Control No. PCN-23131

**PRODUCT/PROCESS CHANGE NOTIFICATION**

An existing qualified leadframe supplier, Hua Yang, will be added as an alternative leadframe supplier for 160x236 mil leadframe to be used for the DPA SMD-8 products listed below.

Existing Leadframe Design (mm)

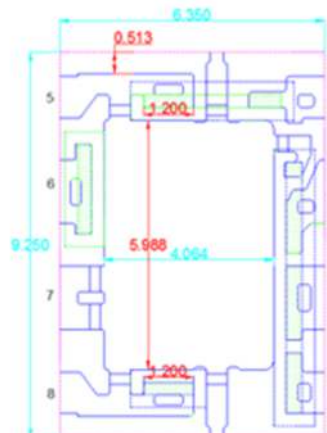
This leadframe internal design configuration will remain the same as shown in the figure below, but there will be some small dimensional changes to inner lead features that will not affect fit, functionality or performance of the product. The plastic body length will also change as shown in the figure, but the new dimension is still within our datasheet package drawing tolerances.
